SUBJECT: ISSUANCE OF AMENDMENT NO. 4 TO AMENDED FACILITY OPERATING
LICENSE NO. R-130 - REGENTS OF THE UNIVERSITY OF CALIFORNIA
(TAC NO. 8391)

Amendment No. 4
License No. R-130

Enclosure:
Appendix A, Technical
Specification Changes

TECHNICAL SPECIFICATIONS
FOR THE
UNIVERSITY OF CALIFORNIA - DAVIS MCCLELLAN NUCLEAR RADIATION CENTER
(UCD/MNRC)

UCD/MNRC ORGANIZATION FOR LICENSING AND OPERATION
FIGURE 6.1

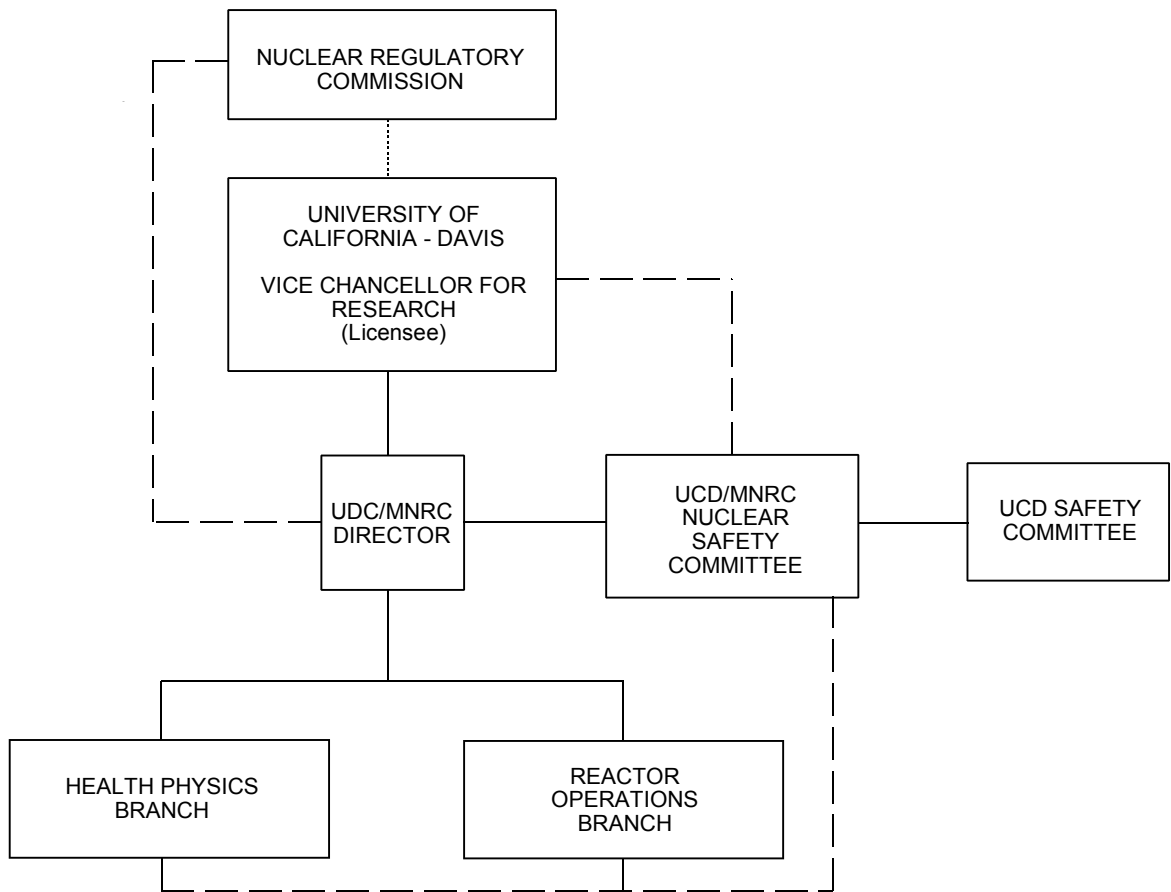
6.1.1 Structure. The management for operation of the UCD/MNRC facility shall consist of the organizational structure as shown in Figure 6.1.

5. Section 5.3.1. A request to add the use of 30/20 TRIGA fuel and a new core fuel loading termed a 30B core.
6. Section 6.0. A request to revise the organization and duties of the Nuclear Safety Committee and to clarify the Committee's review and audit functions to reflect the new licensee.

Section 6.0 of the Technical Specifications describes the administrative controls governing the operation and maintenance of the reactor and associated equipment. There are a number of minor changes with respect to titles and some changes with respect to the composition and duties of the Nuclear Safety Committee (NSC). The review and inspection functions of the NSC have been expanded to provide additional oversight. These expanded functions include review of the Emergency Plan and Physical Security Plan, review and update of the NSC Charter every two years, review of inspections conducted by other agencies, assessment of actions taken to correct deficiencies, inspection of currently active experiments, and inspection of future

plans for facility modifications or facility utilization. Since these changes increase oversight of facility operations, the staff concludes that they are acceptable.
